WILLIAMSON COUNTY, TEXAS

CHANGE ORDER NUMBER: 6

Project:	<u>Forest North Phase 3</u>
Roadway:	<u>Drainage Improvements</u>
CSJ Number:	<u>3866</u>

Change Order No. 6

SCALE
DATE: 7/23/2020
SHEET NO. SB7 OF SB10
SHEET 120 OF 201

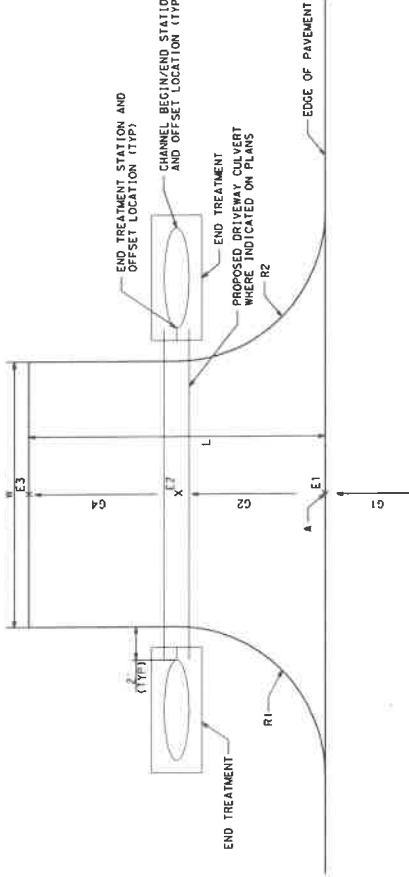
1A: Design Error or Omission. Incorrect PS&E. This Change Order adds an item to pay for 24" RCP 6:1 safety end treatments (SET's) Plan sheet 120 of 201 (SB7 of SB10) calls for the 24" RCP on Chester Forest Street to have 6:1 SET's but no pay items were created to pay for this item on the bid forms.

This Change Order adds a new item to pay the Contractor for 24" Reinforced Concrete Pipe (RCP) 6:1 Safety End Treatments (SET). The plans call to install 6:1 SET's on the 24" RCP at the ends of driveway culverts on Chester Forest in the Sherbourne Zone. On the bid form, no pay item was set up for this work. Item 0467-6392 (SET (TY II) (24IN) (RCP) (6:1) (P)) is added to pay for this work.

ITEM	DESCRIPTION	QUANTITY	UNIT
0467-6392	SET (TY II) (24IN) (RCP) (6:1) (P)	6	EA
